SCHMIDT PARCEL REZONE MULTI-DWELLING

REZONE RM 30

SHEET TITLE
REZONE EXHIBIT

Zoning Map_v1.pdf Markup Summary 11-15-2022

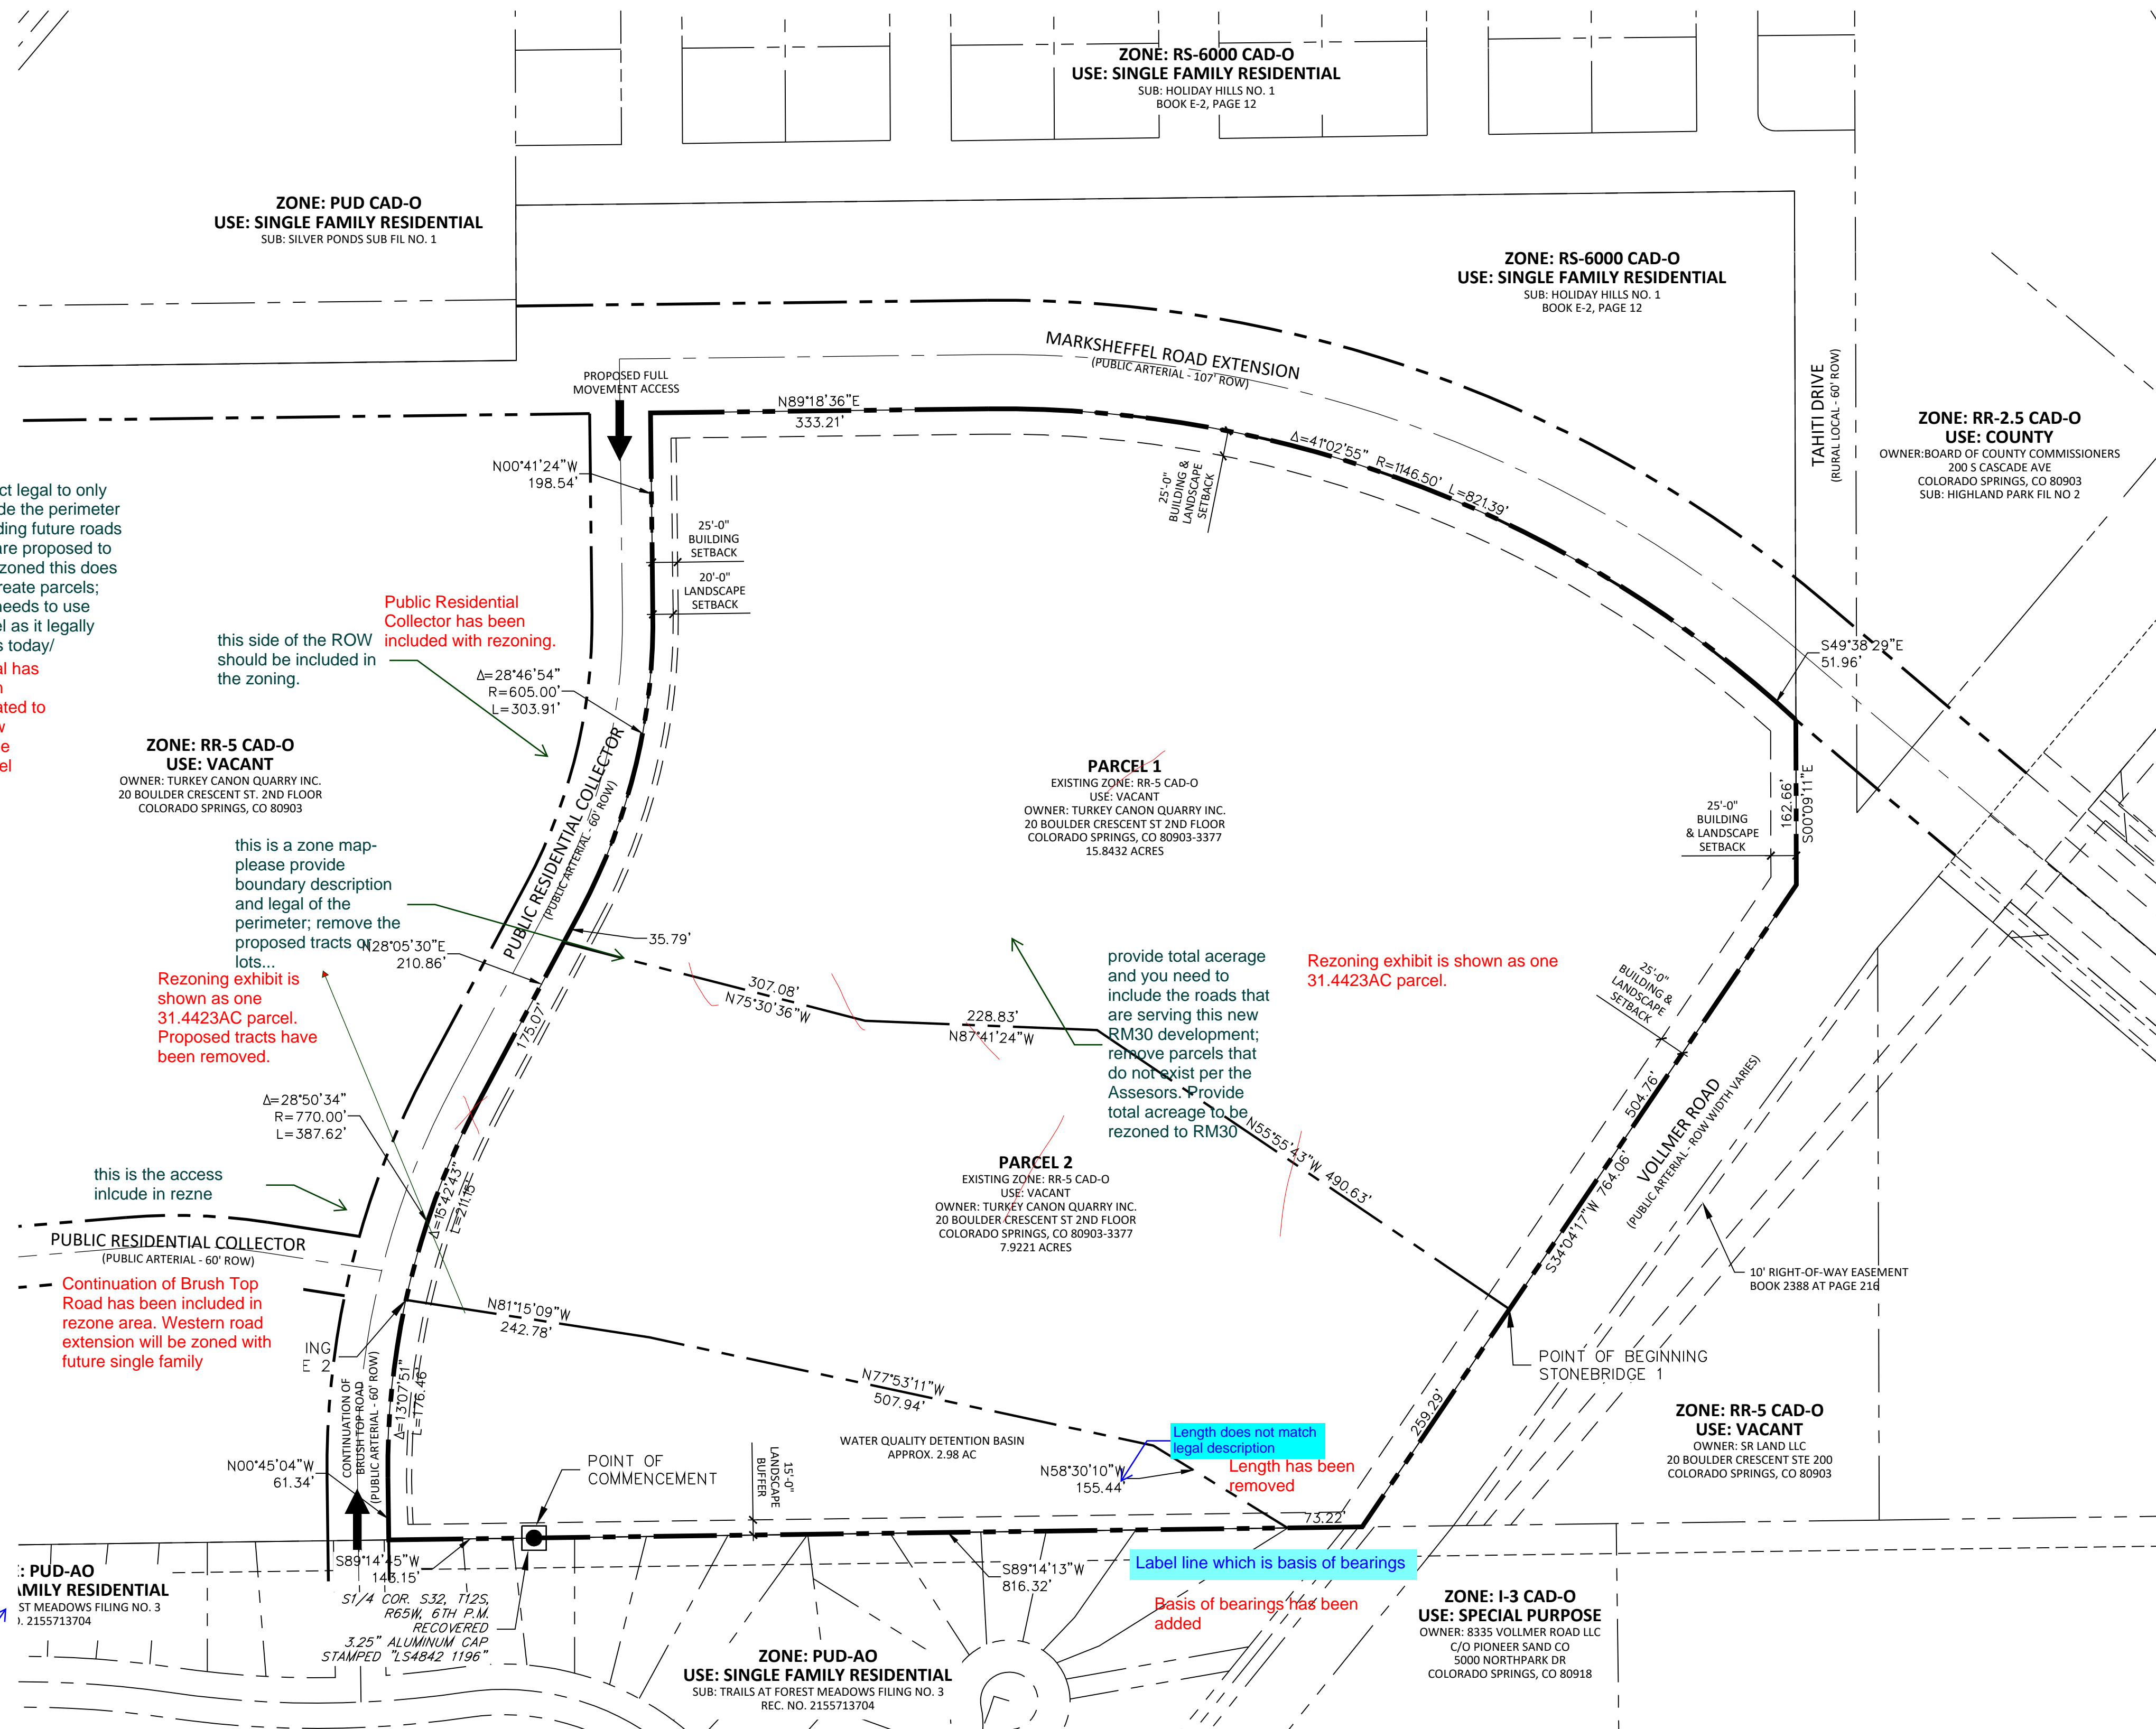
correct legal to only provide the perimeter including future roads that are proposed to be rezoned this does not create parcels; one needs to use parcel as it legally exists today/
Legal has been updated to show single parcel

this side of the ROW should be included in the zoning.
Public Residential Collector has been included with rezoning.

this is a zone map- please provide boundary description and legal of the perimeter; remove the proposed tracts or lots...
Rezoning exhibit is shown as one 31.4423AC parcel. Proposed tracts have been removed.

this is the access include in rezone

provide total acerage and you need to include the roads that are serving this new RM30 development; remove parcels that do not exist per the Assesors. Provide total acreage to be rezoned to RM30.
Rezoning exhibit is shown as one 31.4423AC parcel.

Length does not match legal description
Length has been removed

Label line which is basis of bearings
Basis of bearings has been added

Fix cut off text
Full text shown.

remove split line

i think your proposing to rezone half of the entire single parcel; the legal and map should reflect that.

Continuation of Brush Top Road has been included in rezone area. Western road extension will be zoned with future single family

Legal has been updated to reflect area of rezone
